Subject: Byron Ultimate Heat Sink
 Byron Units 1 and 2,
 NRC Docket Numbers 50-454 and 50-455

Byron/Braidwood UFSAR Change Log

Byron/Braidwood
 UFSAR Change Log
 DRP 4-009

FIGURE 9-2-8

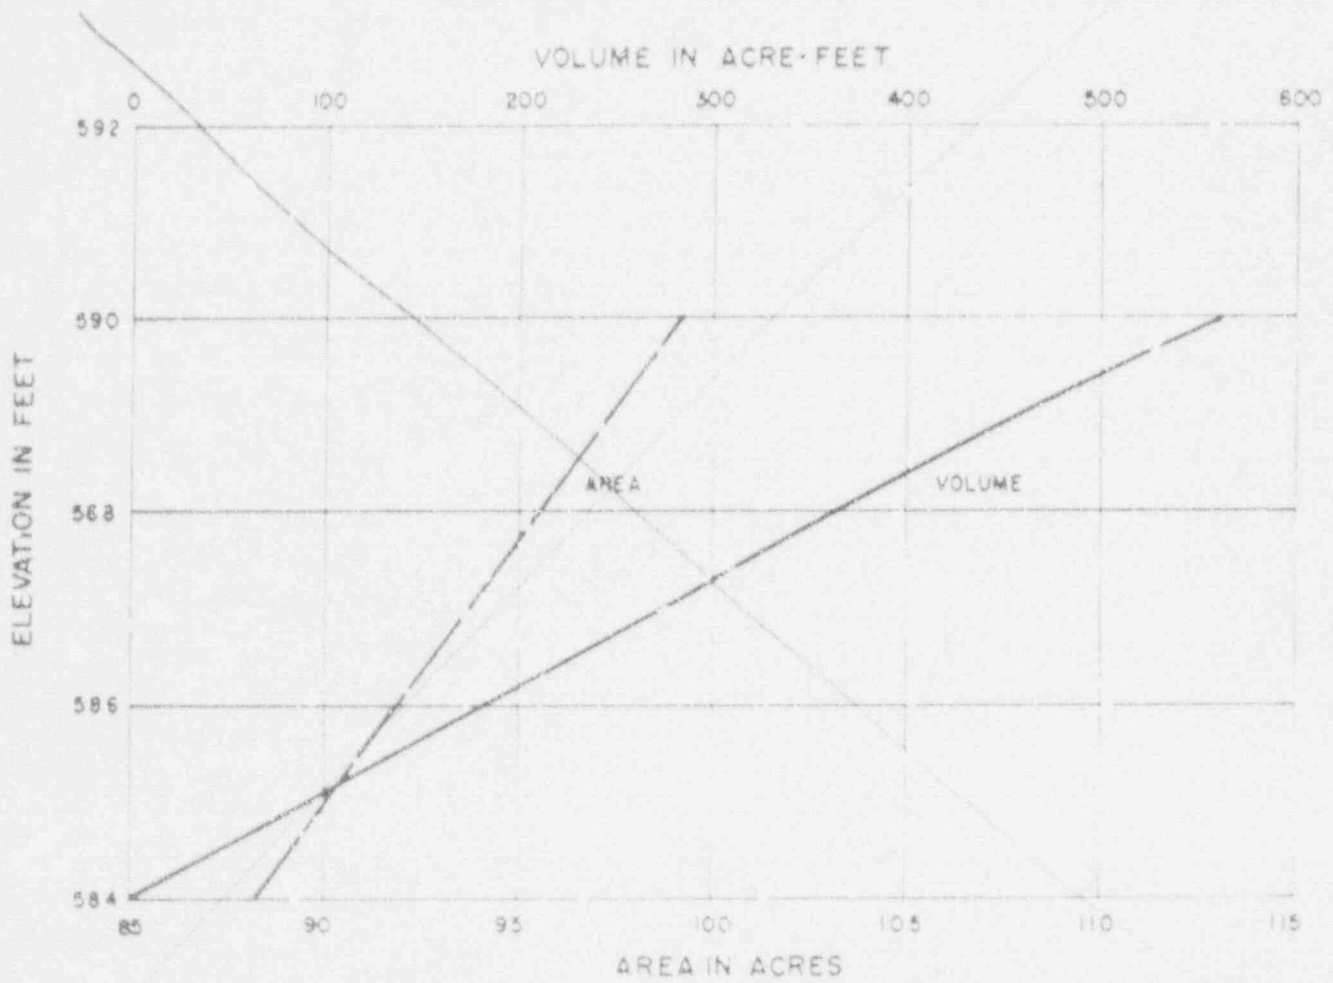
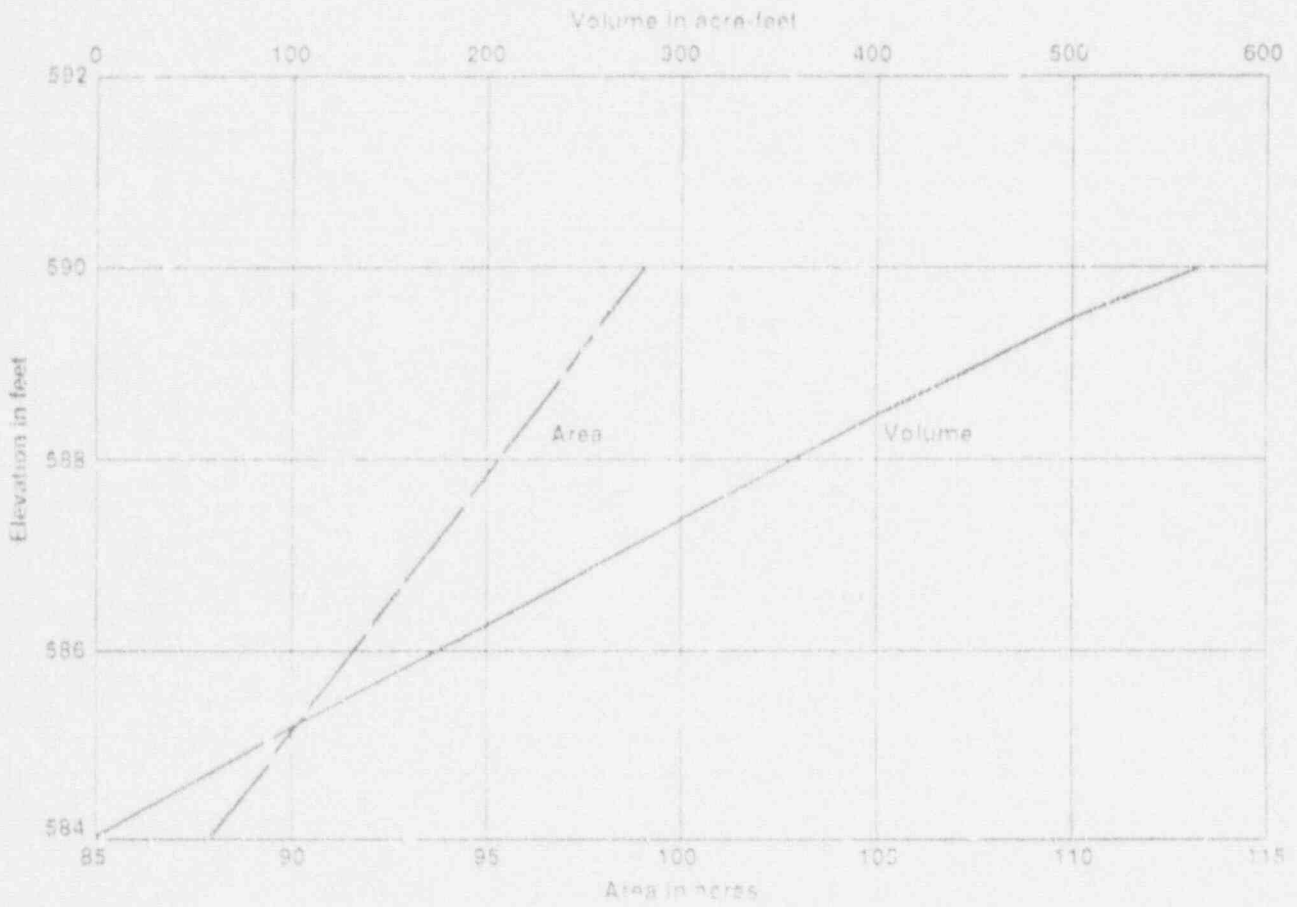
Section	Page	Description of Change	Reason/Basis	References/Remarks
9.0	9.0-xv	Show Figure 9.2-5 as "Deleted"	Editorial	Figure is being deleted
9.0	9.0-xv (cont'd)	Show Figure 9.2-b as "Deleted" and denote Figure 9.2-8 as applying to Braidwood only	Editorial	Changes are per this DRP

Section	Page	Description of Change	Reason/Basis	References/Remarks
9.2	F9.2-7	Revise Figure 9.2-7	Document calculation results	Calculation ATD-0063, Revision 1, dated April 1, 1992
9.2	F9.2-8 to F9.2-14	Change Figures 9.2-8 through 9.2-14 to 'Braidwood Only'	Editorial	Byron does not have a cooling pond
9.2	F9.2-9 to F9.2-14	Replace Figures 9.2-9 through 9.2-14	Document calculation results	"Thermal Performance of the Ultimate Heat Sink During a Loss of Coolant Accident," S&L Calculation ATD-0109, Revision 1, April 27, 1992
9.2	F9.2-30	Add Figure 9.2-30	Document calculation results	Calculation RSA-B-91-03, Figure 14
9.2	F9.2-31	Add Figure 9.2-31	Document calculation results	Calculation RSA-B-91-03, Figure 15

Replace with a new figure

FIGURE 9-2-9

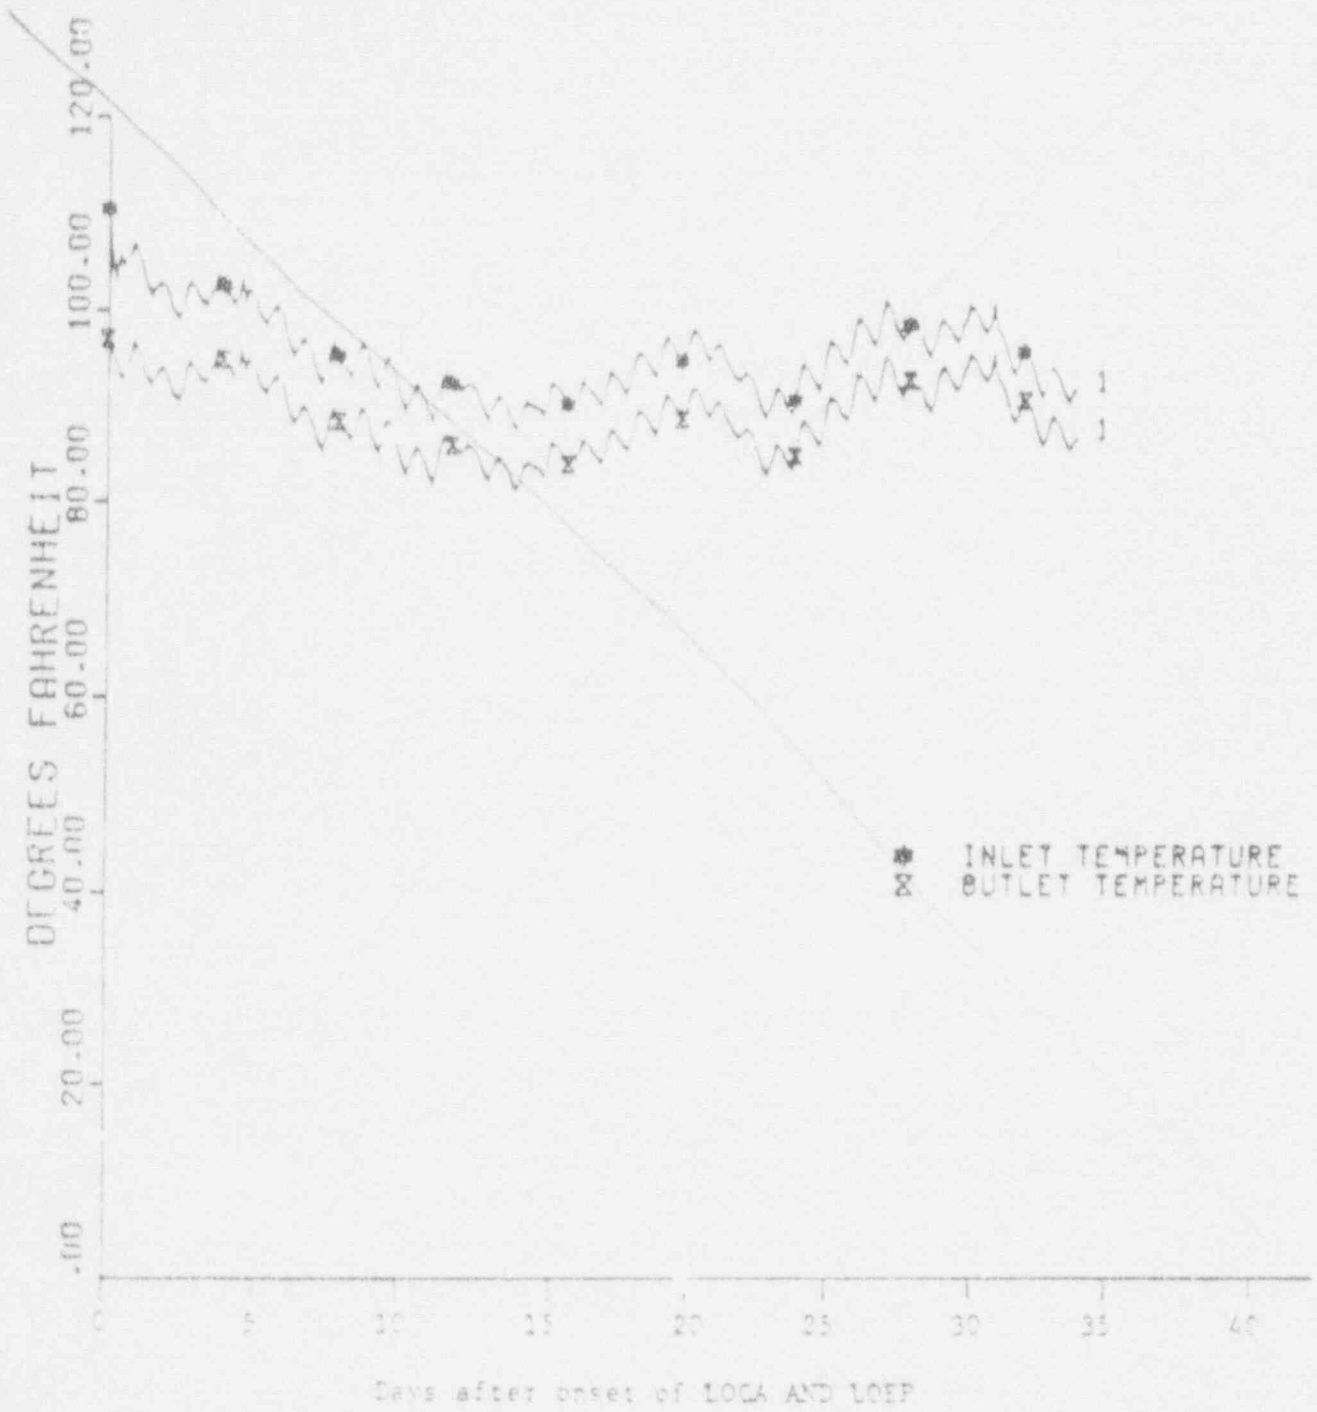
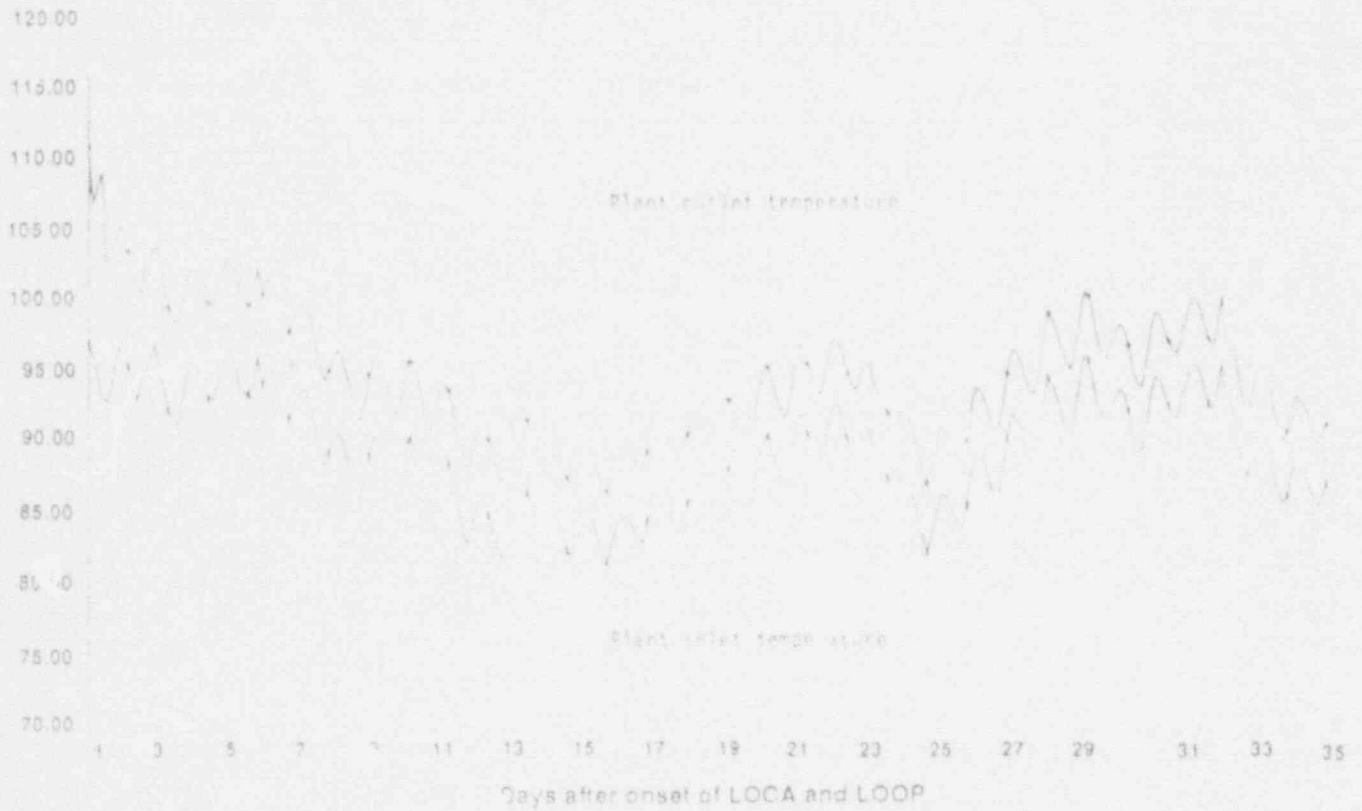
9.0	9.0-xvi	Denote Figures 9.2-9 through 9.2-14 as applying to Braidwood only, add Figures 9.2-30 and 9.2-31	Editorial	Changes are per this DRP
9.2.1.2.1	9.2-2	Revise section	Reflect design basis	IHS Final Report

Replace with a new figure

FIGURE 9.2-10

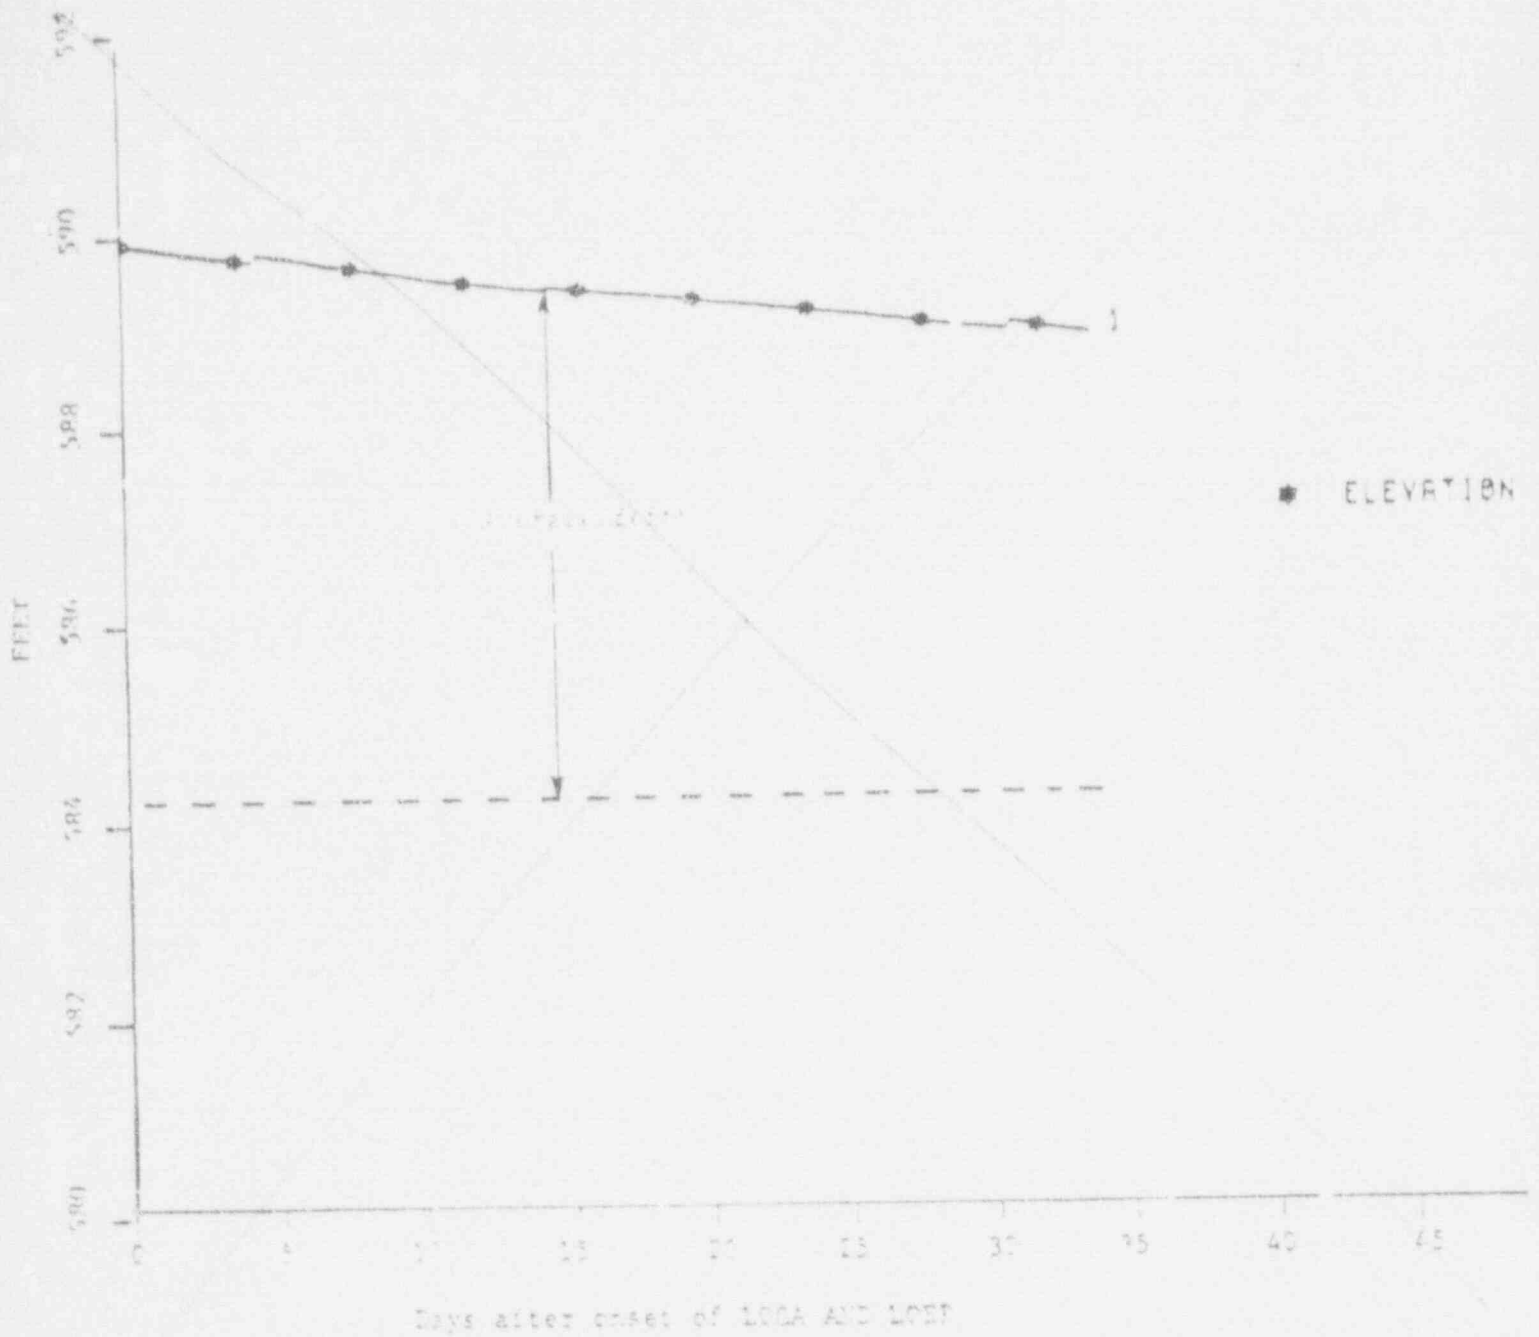
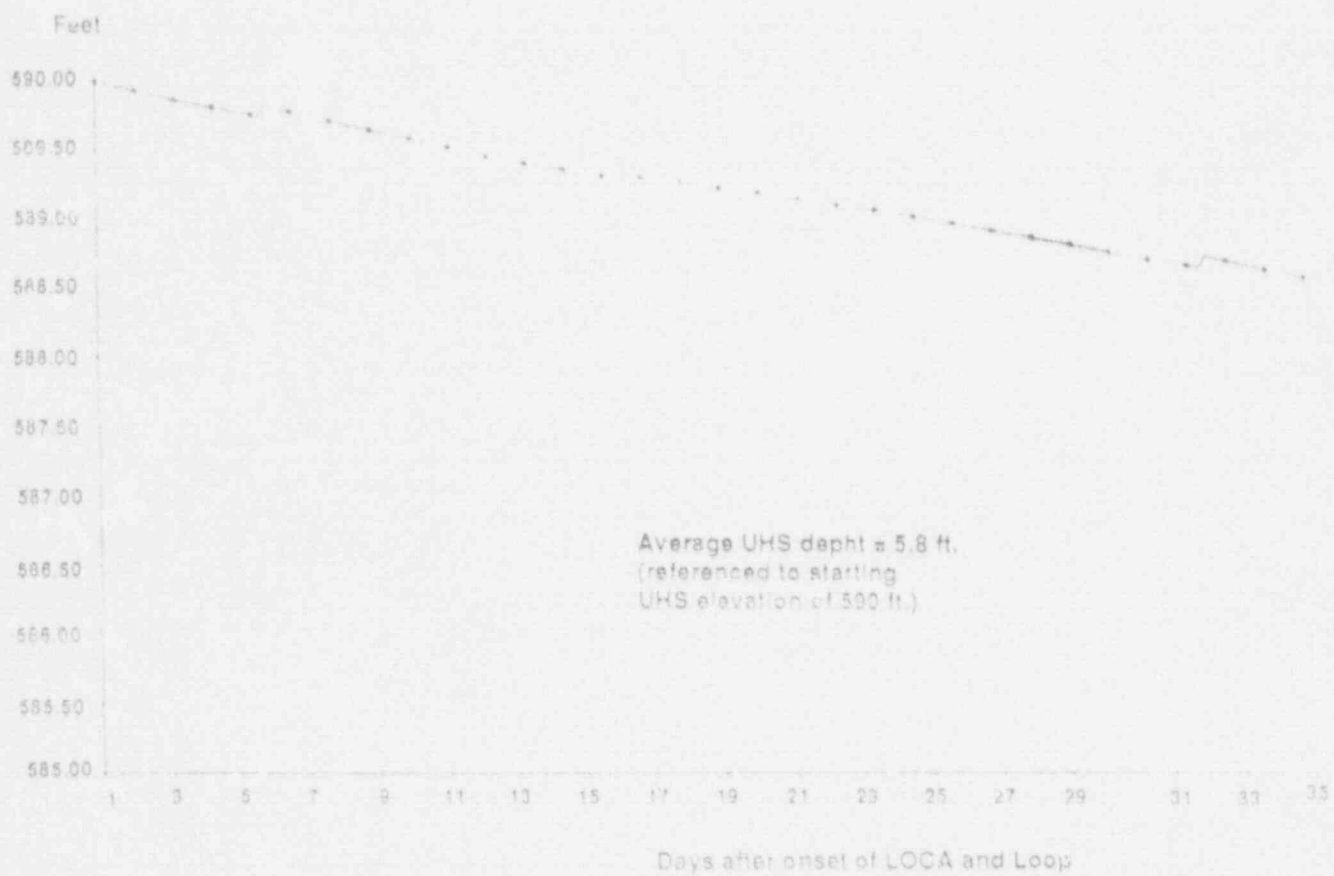
Replace with a new figure
